REQUEST

Current Zoning: R-3 LWPA (single family residential)
Proposed Zoning: MX-2 LWPA (mixed use development)

Approximately 43.58 acres located on the southwest side of Belmeade Drive, northwest of Rhyne Rd.

**STAFF
RECOMMENDATION**

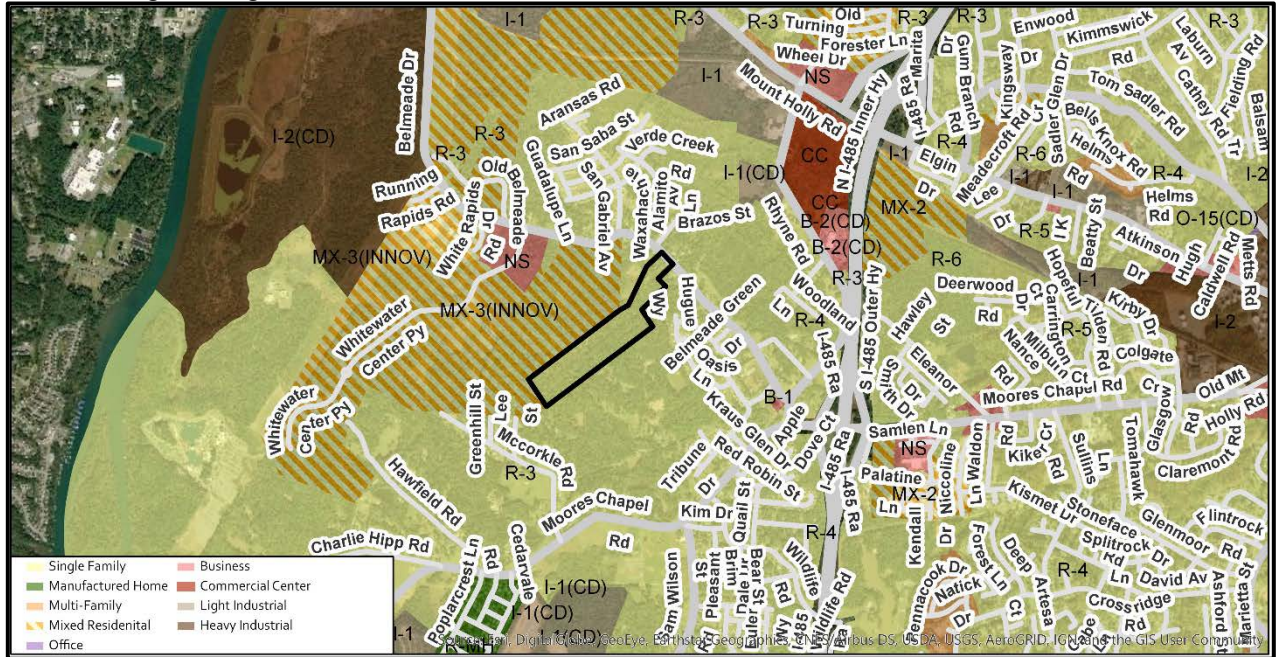
1. Commit to construct the curb and gutter along Belmeade Drive as per required under Chapter 19. The site plan should locate and dimension the curb and gutter from the road centerline. The location of the future back of curb on Belmeade Drive is 25 feet as measured from the Belmeade's existing centerline. The location of the curb and gutter includes space for bicycle facility.
2. Revise the site plan to add a note specifying all transportation improvements will be approved and constructed before the site's first building certificate of occupancy is issued. The petitioner may phase transportation improvements if said improvements and phasing are explicitly described in site plan notes.
3. Revise the site plan and transportation conditional 3.k to provide 80 feet of total right-of-way through the site. A minor thoroughfare requires 80 feet total right-of-way outside Route 4.

4. Modify Architectural Standards Note 4.h. to specify minimum thickness of proposed vinyl siding on an attached dwelling will be .042 inches.
5. Label 37.5 Class C buffer (reduced with berm/fence) on the site plan.

6. Remove the "APPROXIMATE 40' SWIM BUFFER" label from the rezoning site plan (there is no such buffer).
7. Please remove the reference to the *Approximate 40-foot SWIM Buffer*. Buffers through this portion of the site are shown with the *35-ft PCSO Buffer and 100-ft LWPA Watershed Buffer*.
